Access Compliance Report

Public Rights-of-Way

Intersection ID: 29629	Main Street: WINGET_RD	Cross Street: PLANTERS_ESTATES_DR	Location: NE
ADA ID: 6797E23D834D	Ramp Type: PerpDiag	Initial Pass/Fail: Pass	Overall Compliance: No
		Severity Score: 10

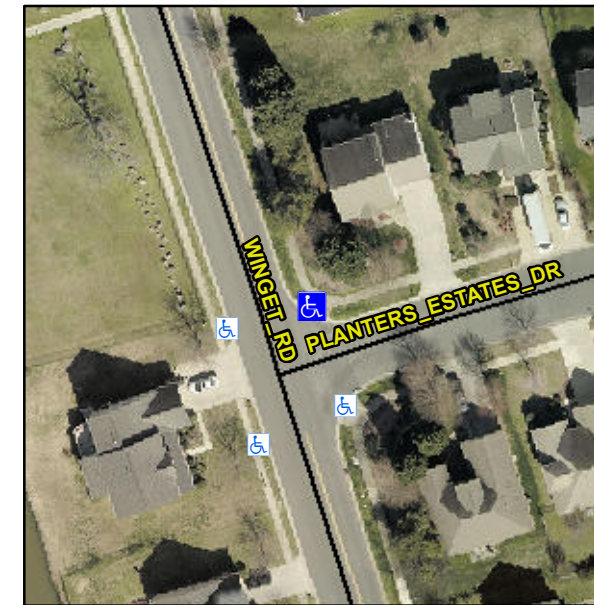
Not Found, R305

Compliance	Description	Data	Compliance	Description	Data
N/A	Ramp Length (in)	83.0	Yes	Ramp Slope (%)	5.3
Yes	Ramp Width (in)	52.0	Yes	Ramp XSlope (%)	1.8
N/A	Flare Type LT	Sloped	N/A	Flare Type RT	N/A
N/A	Flare Slope LT (%)	0.8	N/A	Flare Slope RT (%)	1.9
N/A	Flare Traversable LT?	No	N/A	Flare Traversable RT?	No
Yes	Landing Length (in)	60.0	No	DWS Provided?	No
Yes	Landing Width (in)	52.0	N/A	DWS Contrast?	No
Yes	Landing Slope (%)	1.1	N/A	DWS Length (in)	N/A
Yes	Landing X Slope (%)	1.4	N/A	DWS Full Width?	No
N/A	Landing Curb? (Y/N)	No	N/A	DWS Offset (in)	N/A
N/A	Shared Landing?	No			
Yes	Gutter Ponding?	No	Yes	Gutter Slope (%)	1.1
Yes	Gutter Lip Ht (in)	0.0	Yes	Gutter X Slope (%)	1.9
N/A	Painted X Walk1?	No	N/A	Painted X Walk2?	No
	X Walk 1 Direction	To W		X Walk 2 Direction	To S
N/A	X Walk 1 Width (in)	N/A	N/A	X Walk 2 Width (in)	N/A
	X Walk 1 Slope (%)	1.2		X Walk 2 Slope (%)	3.0
	X Walk 1 X Slope (%)	5.0		X Walk 2 X Slope (%)	0.2

Remove & Replace Curb Ramp With Two New Directional Ramps or Equivalent.
